EPC STORMWATER REVIEW COMMENTS
IN ORANGE BOXES WITH BLACK TEXT

Landscape Endeavors Building Addition

Commercial Construction Drawings

Landscape Endeavors Building Addition
CES Endeavors, LLC
Civil Site Plan
El Paso County, Colorado

Landscape Endeavors Building Addition
 CES Endeavors, LLC
 Grading and Erosion Control - Details
 El Paso County, Colorado

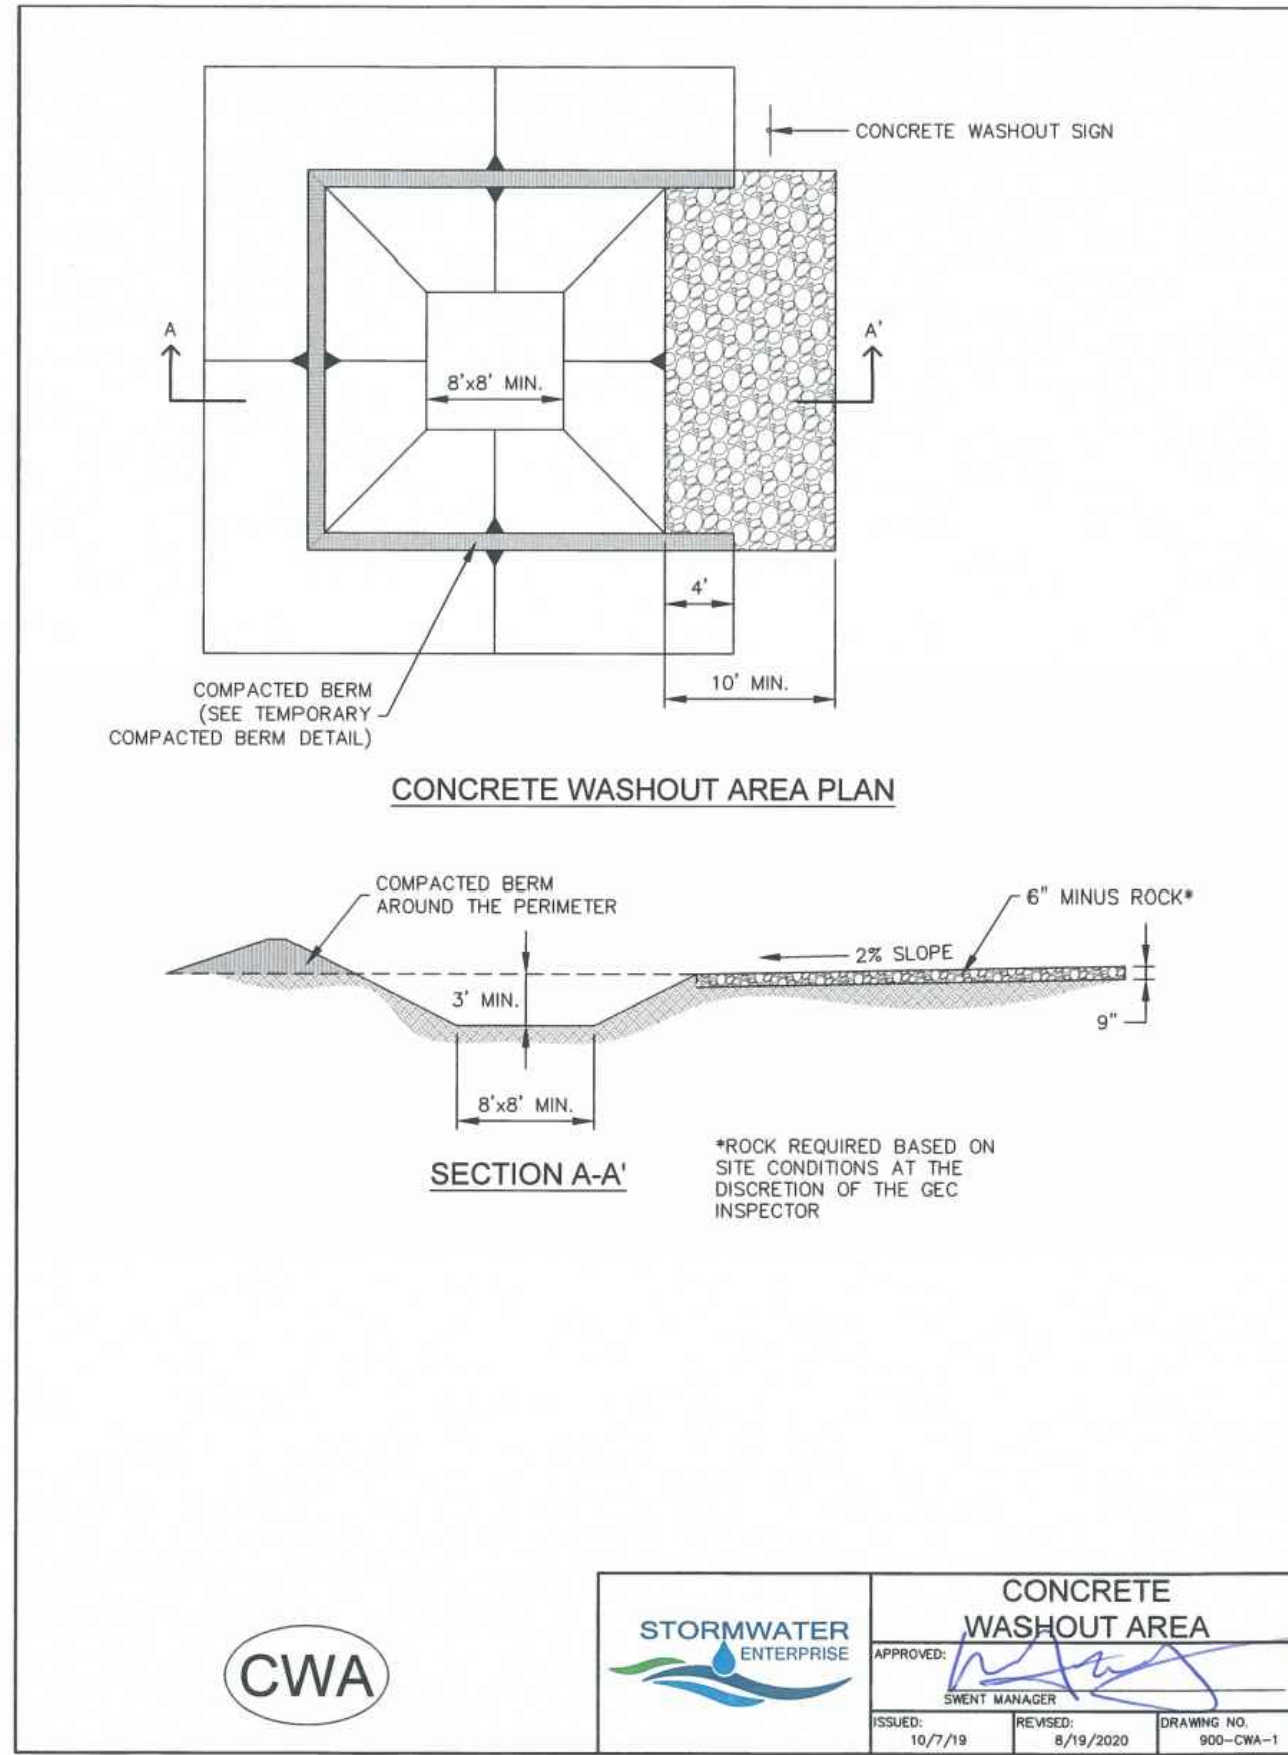
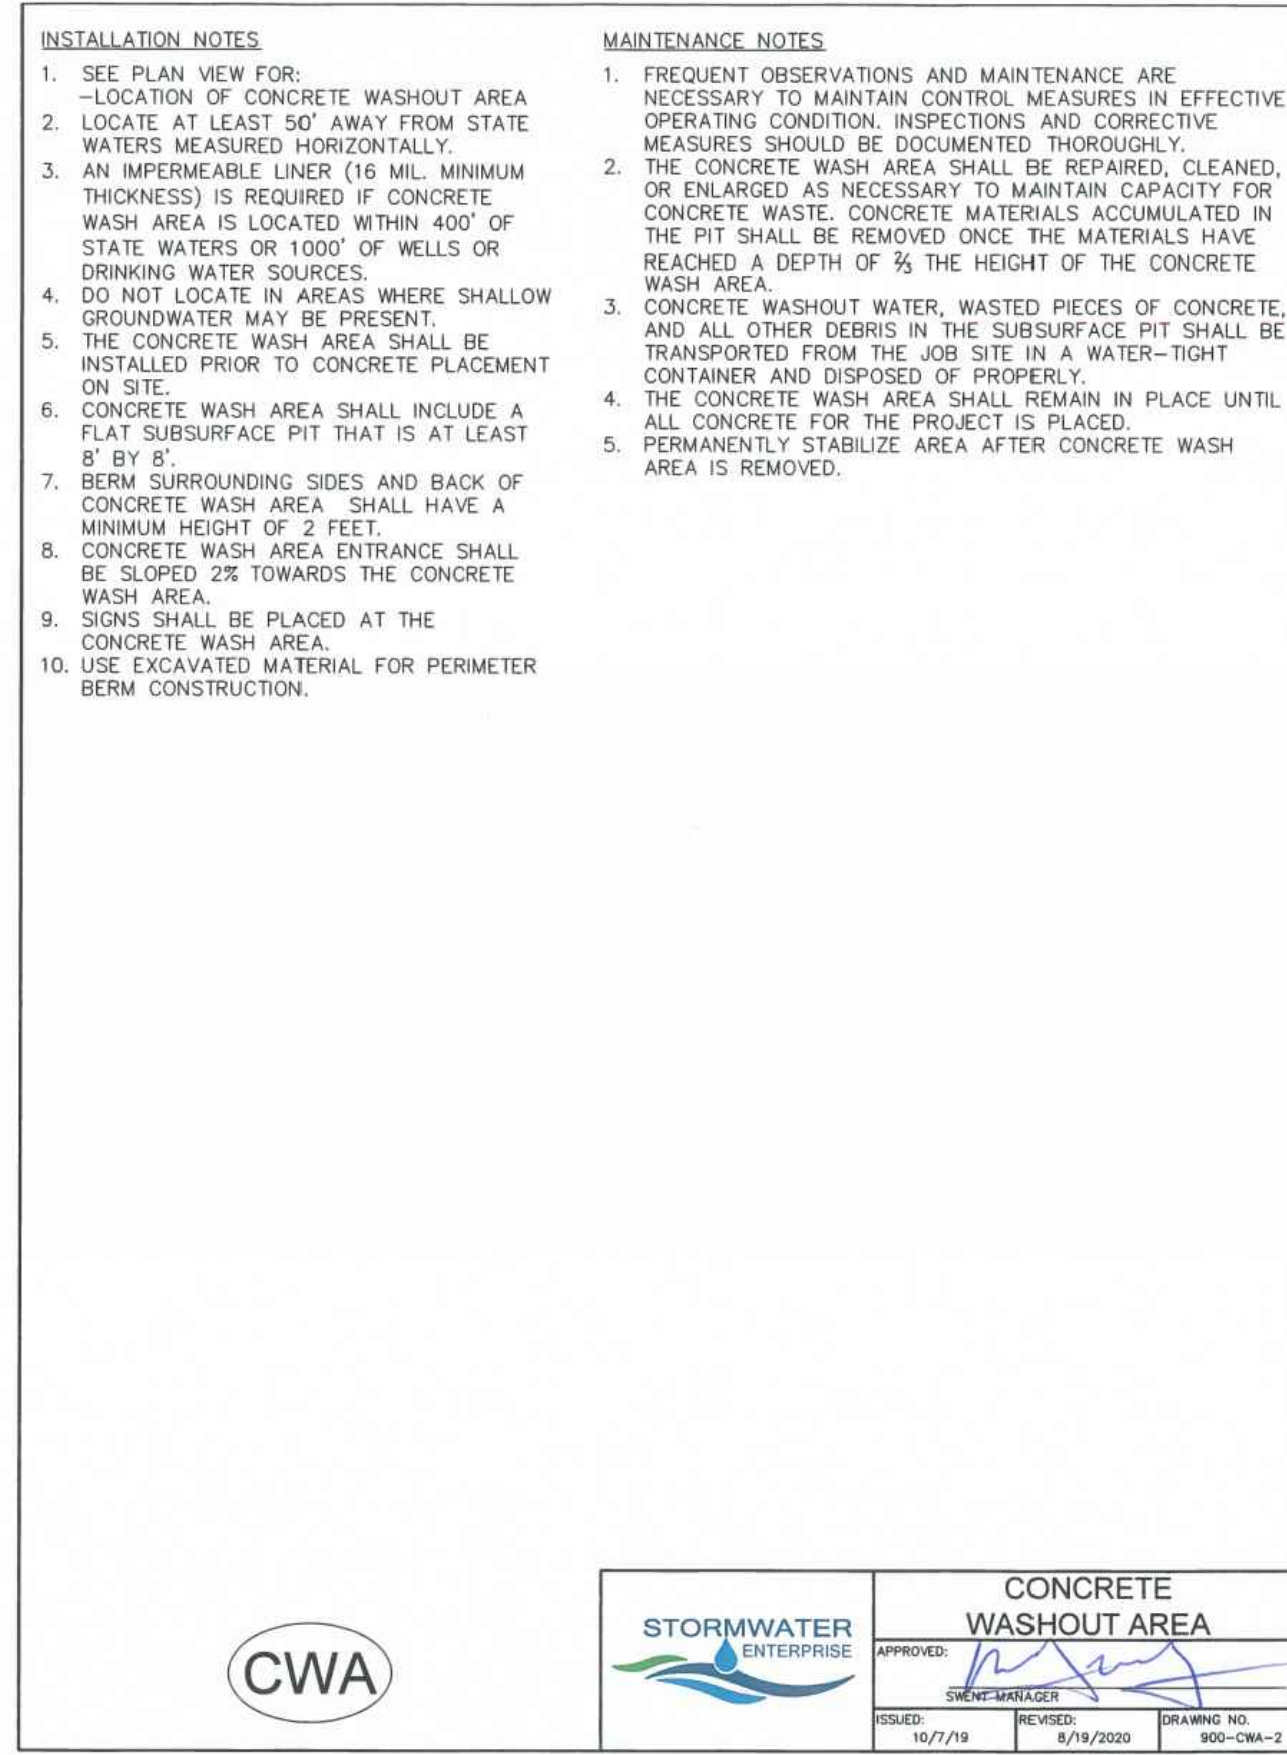
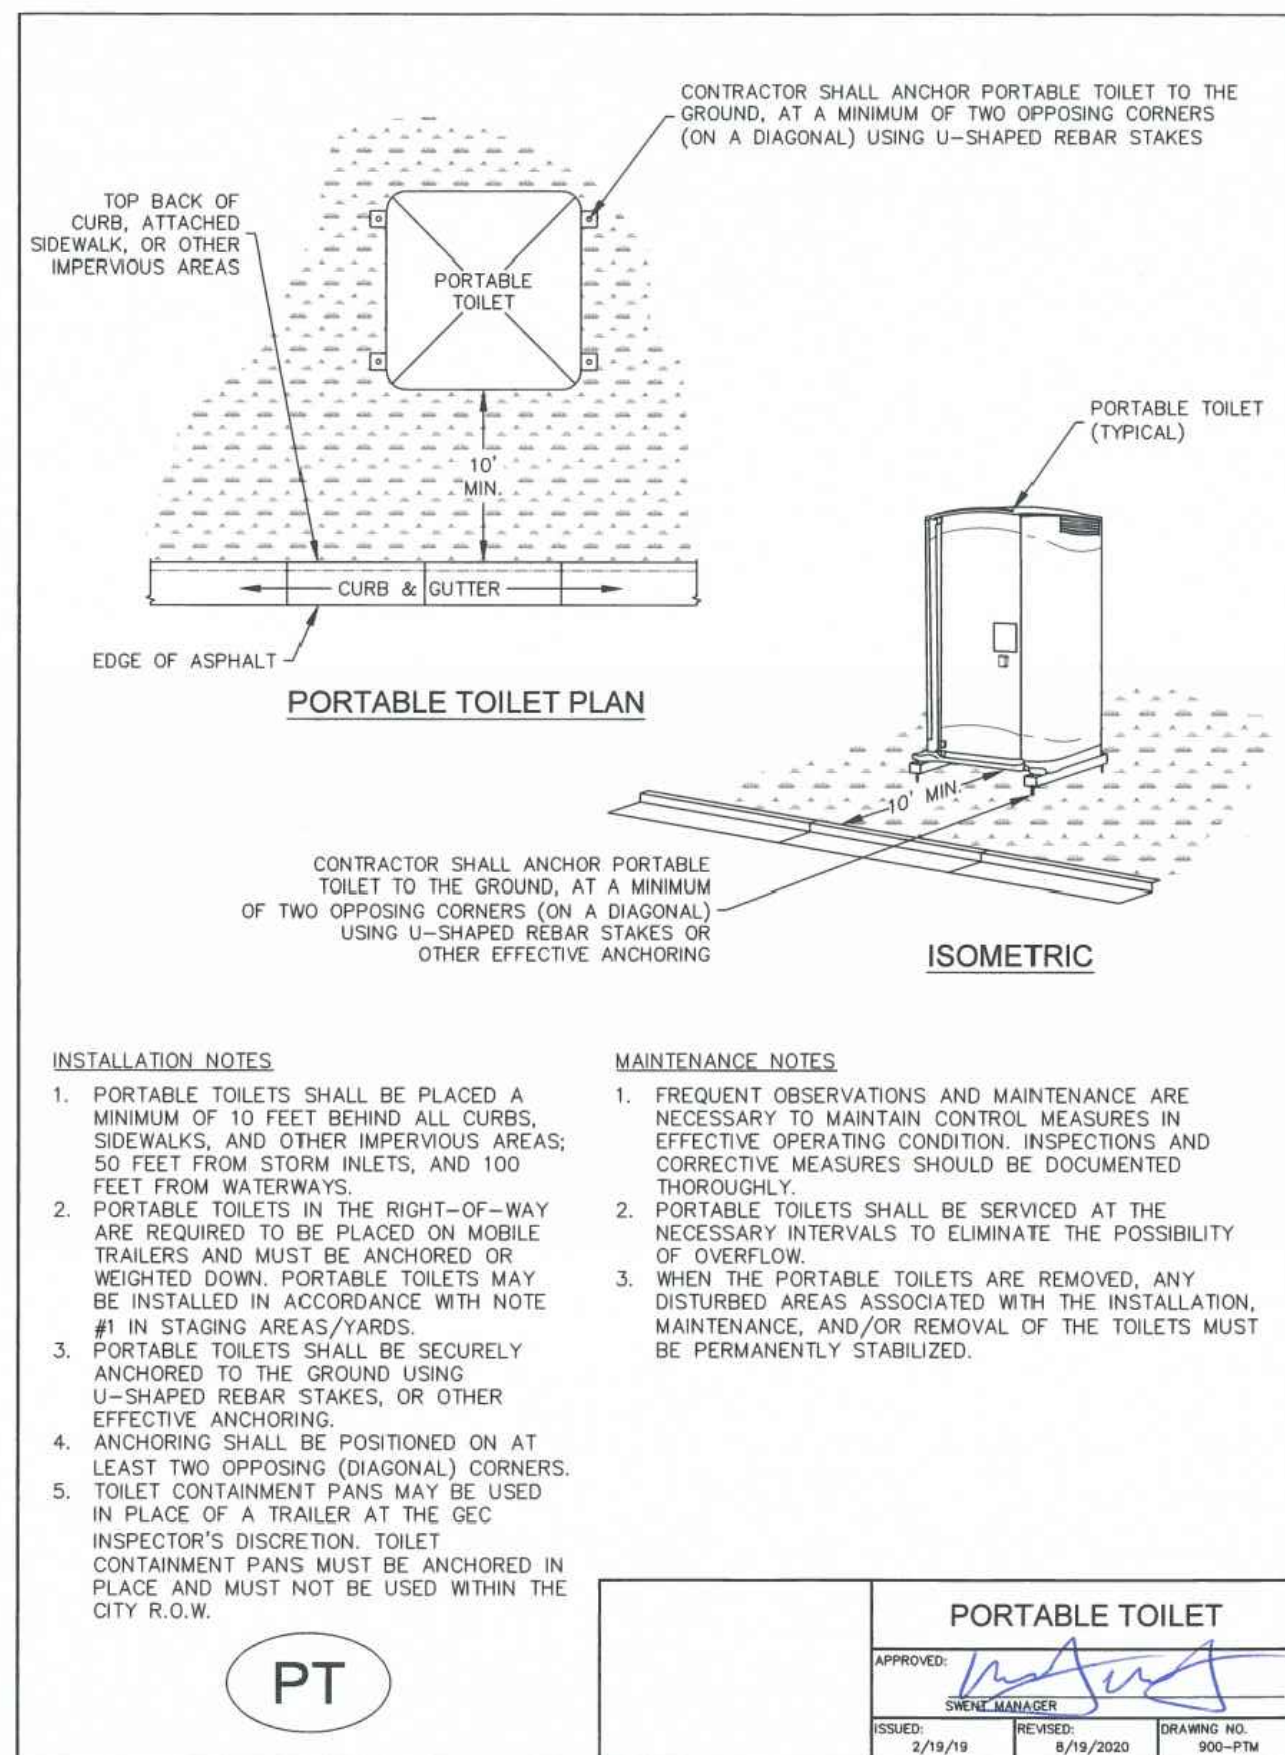
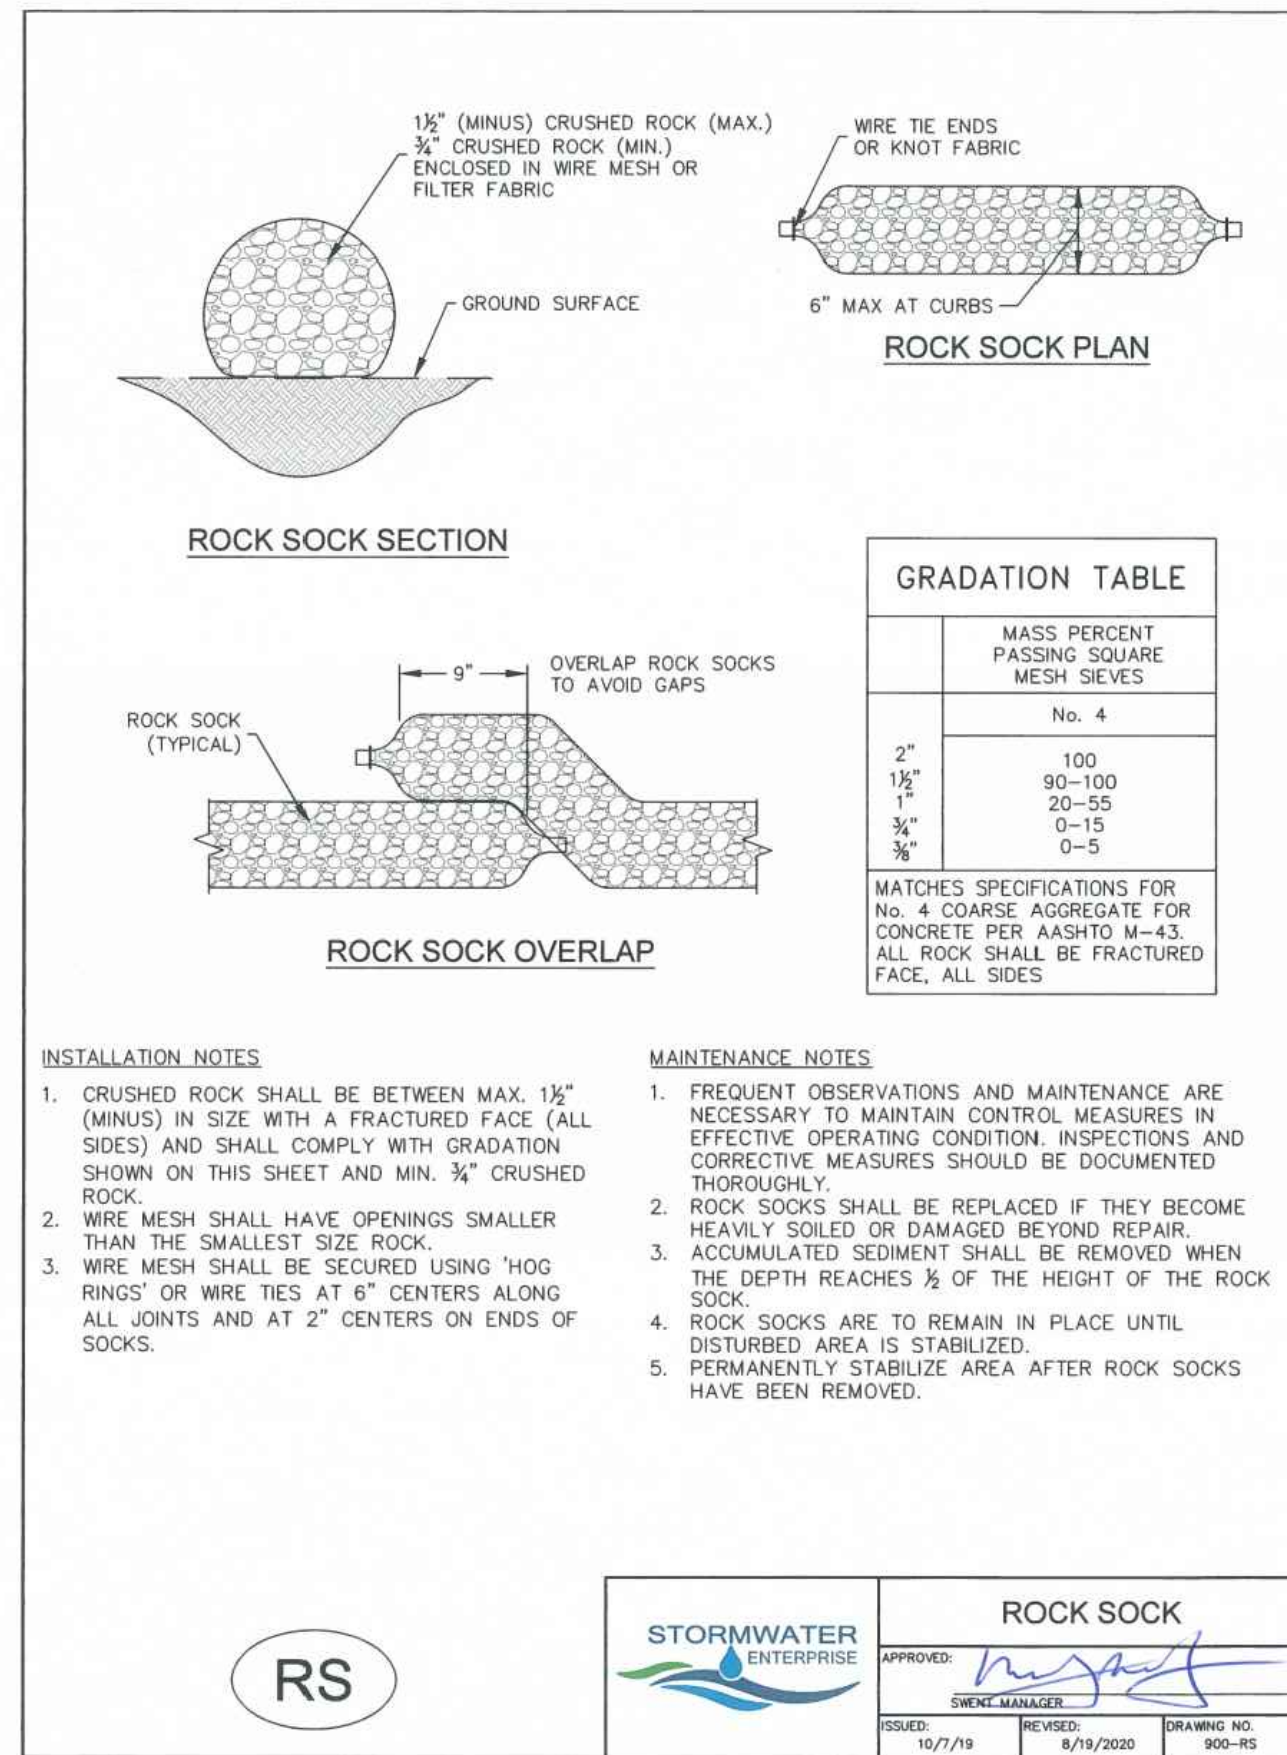
SWMP Checklist Item 20 - Include details for: sediment control log, inlet protection, and stockpile management.
